H. B. ROBINSON STEAM ELECTRIC PLANT, UNIT NO. 2
DOCKET NO. 50-261
LICENSE NO. DPR-23
IE BULLETIN 80-11,
MASONRY WALL DESIGN

As requested by your letter dated October 4, 1982, Carolina Power & Light Company (CP&L) has completed the response to your request for additional information regarding IE Bulletin 80-11, Masonry Wall Design, for the H. B. Robinson Steam Electric Plant Unit No. 2 (HBR2).

CONCRETE MASONRY WALLS
RESOLUTION OF NRC QUESTIONS
ON IE BULLETIN 80-11

SAMPLE CALCULATIONS FOR A TYPICAL
MULTI-WYTHE WALL

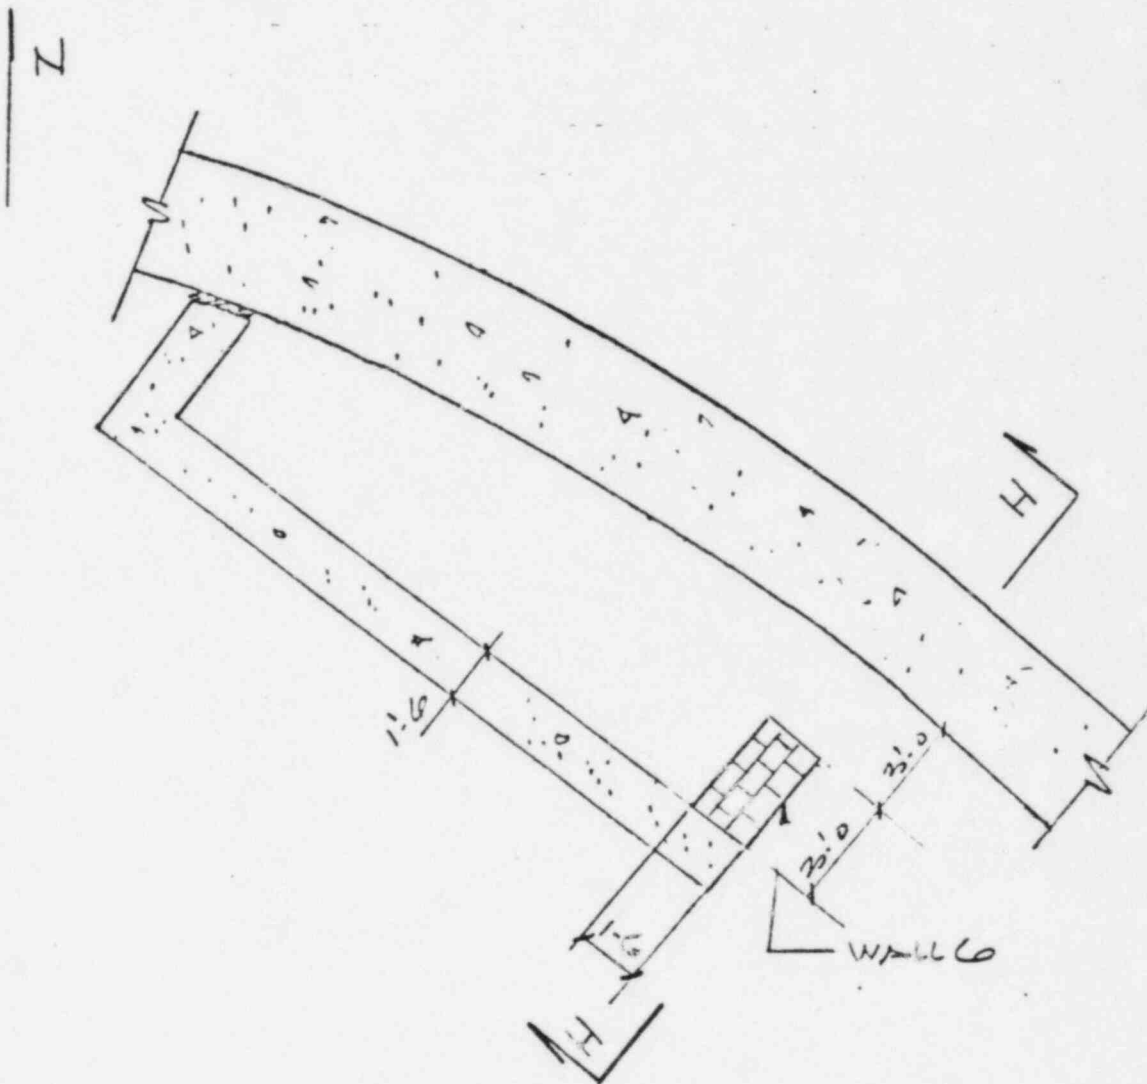
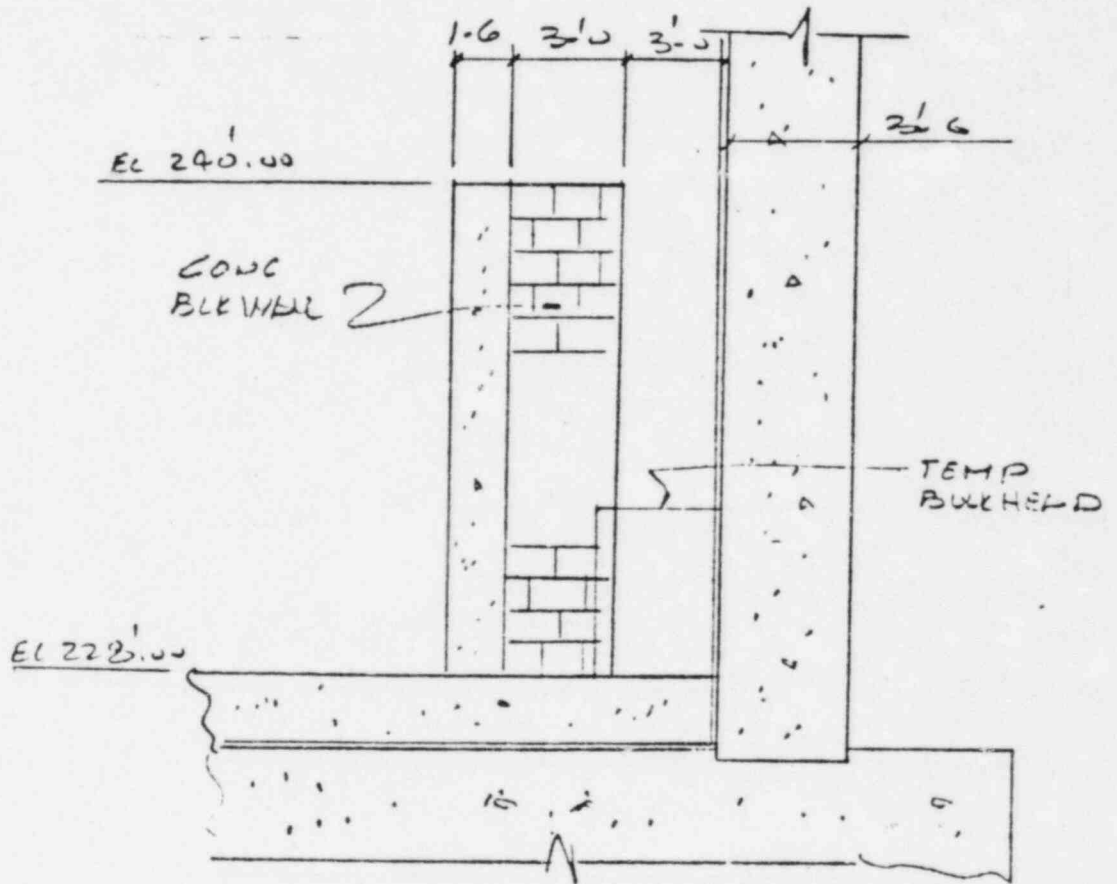
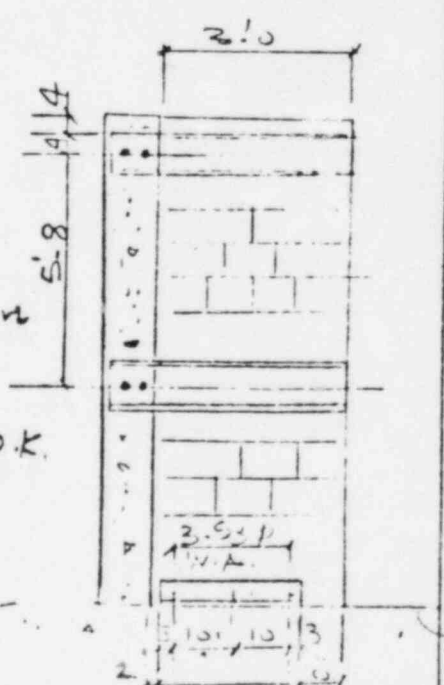
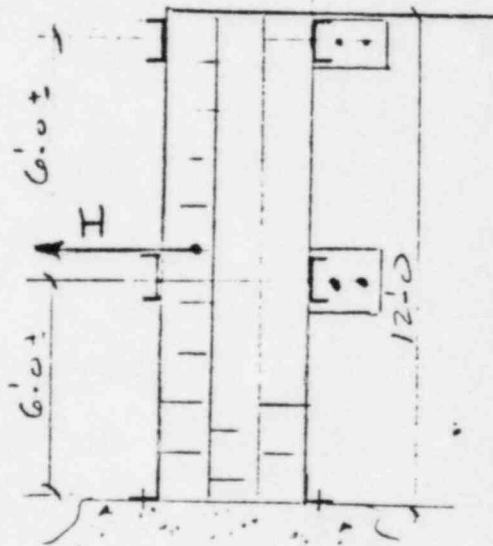
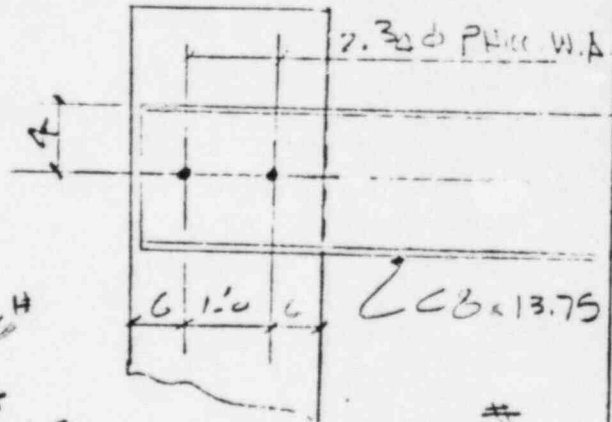
NRC Comment 8: Provide sample calculations for:

- (a) block pullout analysis for attachments
- (b) missile impact (if applicable)
- (c) a typical multi-wythe wall.

- Ebasco Response: (b) Postulated missile impact loads are not applied to the Category I masonry walls considered in this report, since all the block walls are considered protected from this type of loading.
- (c) Even though multi-wythe walls are provided, no additional strength due to that fact is considered. Consequently, all masonry wall analyses used for final design are based on the assumption that the walls are single wythe. (Note that the steel support framing is designed to resist loads induced by all wythes of multi-wythe walls). However, as noted in Reference 3¹, calculations to account for the multiple wythes were performed and a sample is attached in Appendix A.

These horizontal accelerations (and associated vertical accelerations) are greater than the values used in the analysis of Wall 6. A review of the analysis of Wall 6 (included as a sample calculation in Appendix A) reveals that the designed modifications are capable of withstanding these higher acceleration values.
